<b>FBC CPCN FOR THE KELOWNA BULK TRANSFORMER ADDITION PROJECT EXHIBIT A-3</b>
---

**Re: FortisBC Inc. – Application for a Certificate of Public Convenience and Necessity for the Kelowna Bulk Transformer Addition – Project 1599088 – Information Request No. 1**

**INFORMATION REQUEST NO. 1 TO FORTISBC INC.**

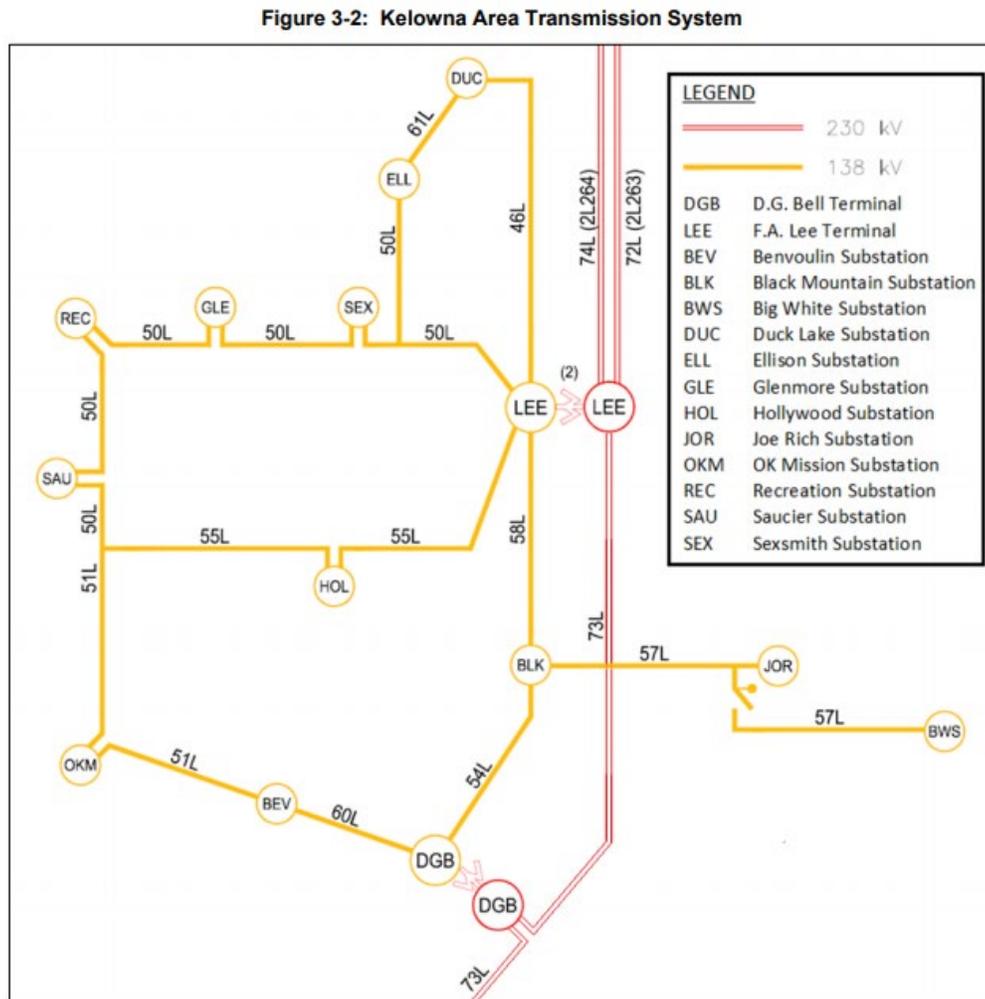
- 6.8 Please discuss if FBC considers transmission line 57L, as shown in Figure 3-2, to be a radial transmission line.
- 6.8.1 Please confirm the 2019 summer and winter peak load data for all load connected to 57L.
- 6.9 Other than the transformer capacity being considered in this Application, please identify if there are any other power system elements in the Kelowna area (where FBC considers N-1 planning criteria to apply) that are at risk of not maintaining the N-1 planning criteria for the 2020-2030 time period. Please include in the response FBC's plans to address these items.
- 6.10 Please discuss the contingency scenarios for FBC's 230 kV system in Kelowna in the 2020-2028 time period. Specifically, please confirm that any one of transmission lines 74L, 72L or 73L can be taken out of service while still maintaining service to Kelowna area load.

**Figure 4-1: Kelowna Area Peak Loads and N-1 Transformer Limits (LEE Alternatives)**

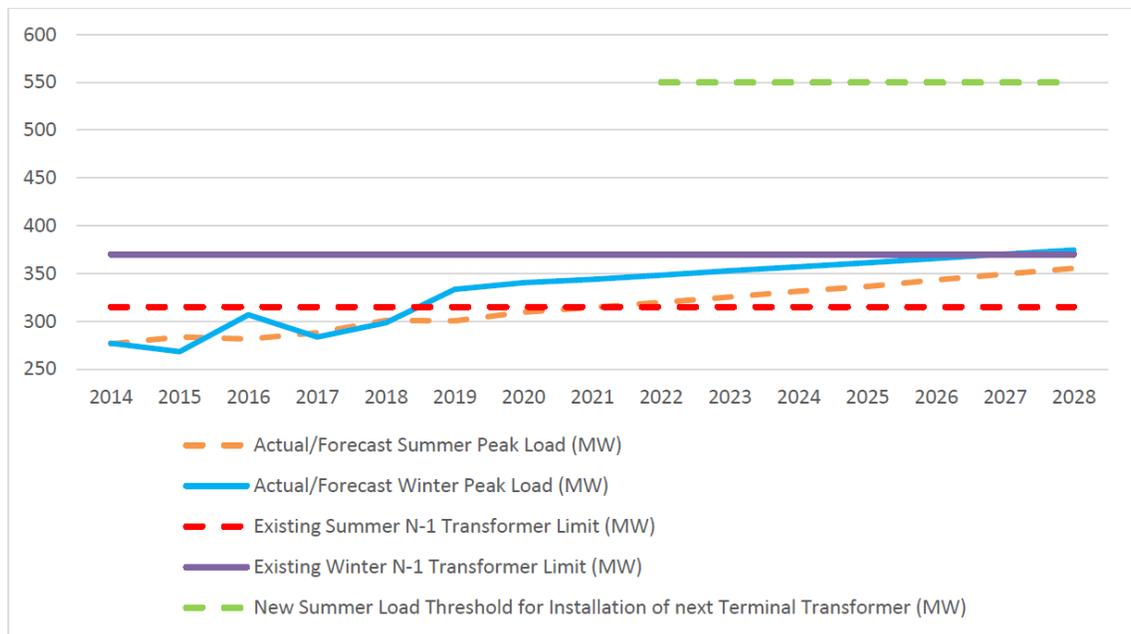
- 11.1 Please update Figure 4-1, with the time axis extending to 2042, 20 years beyond the in-service date of the project.
- 11.2 Please confirm when (i.e. what year) FBC expects Kelowna area peak summer load to reach 550MW.
- 11.3 Please provide the data set for Figure 4-1 in a fully functioning Excel spreadsheet.

**Figure 4-2: Kelowna Area Peak Loads and N-1 Transformer Limits (DGB Alternative with 60L and 51L Reconductoring)**

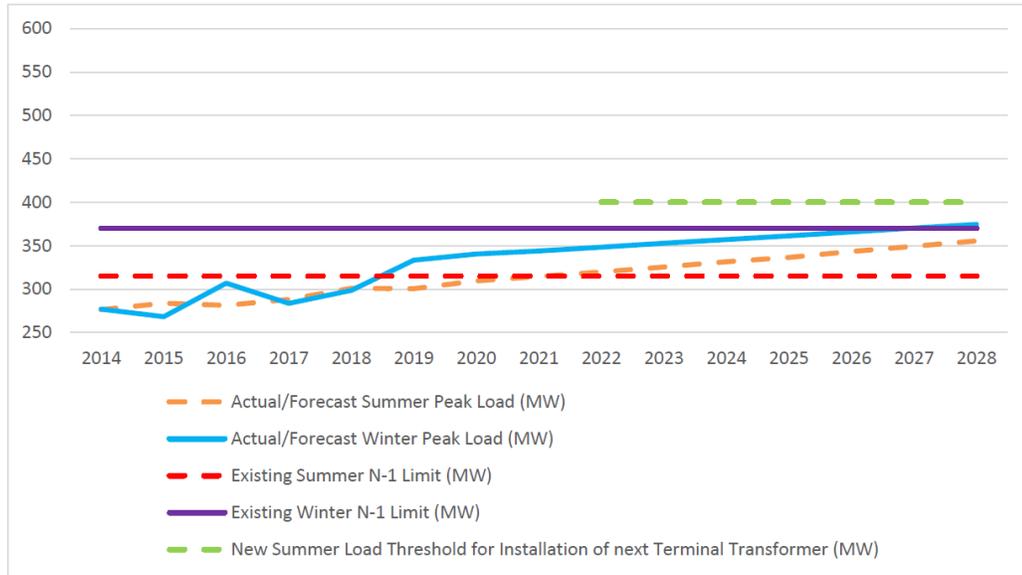
11.4 Please update Figure 4-2, with the time axis extending to 2042, 20 years beyond the in-service date of the project.

**Figure 5-1: LEE Terminal Ring Bus Simplified Single Line Drawing**

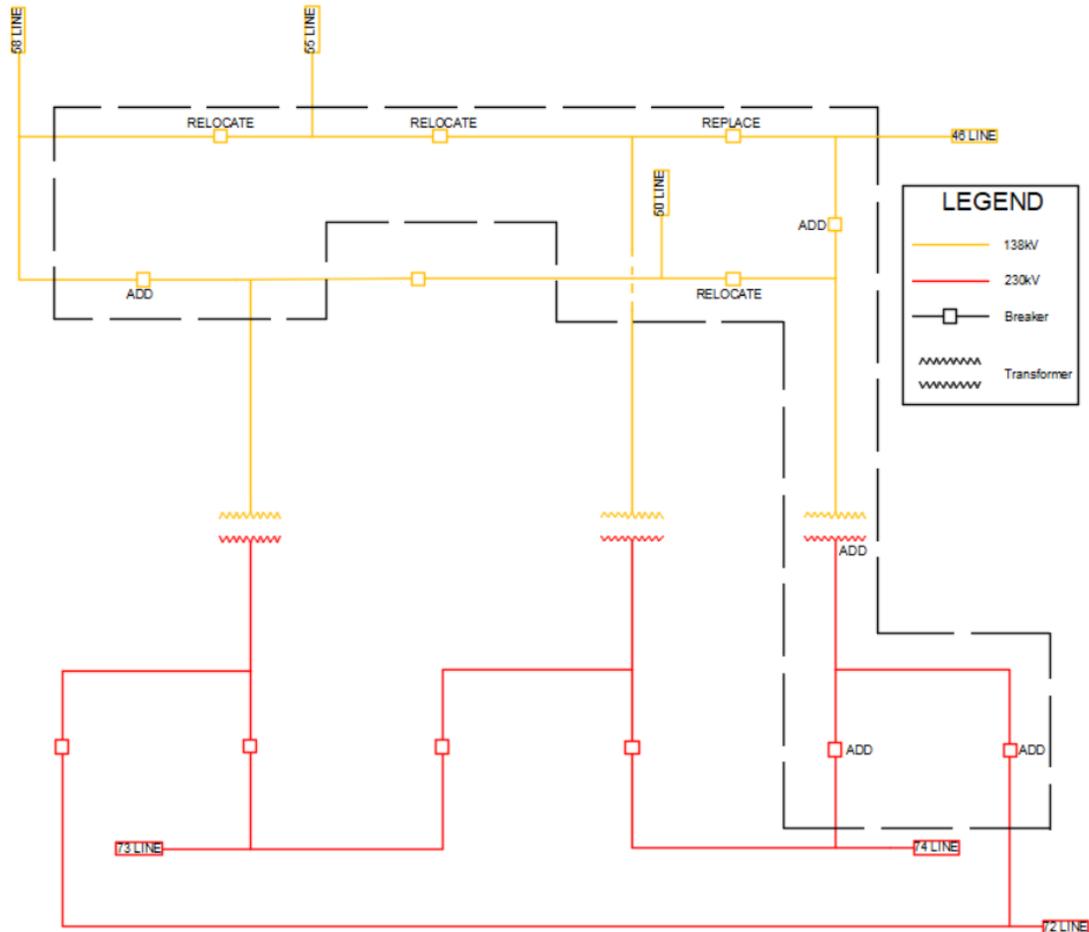
- 18.1 Please provide an updated Figure 5-1, with the transformers and circuit breakers labelled.
- 18.2 Please provide a similar Simplified Single Line Drawing for LEE substation today.
- 18.3 Please provide a similar Simplified Single Line Drawing for DGB substation today.
- 18.4 Please provide a similar Simplified Single Line Drawing for LEE substation under Alternative B.
- 18.5 Please provide a similar Simplified Single Line Drawing for DGB substation under Alternative C.
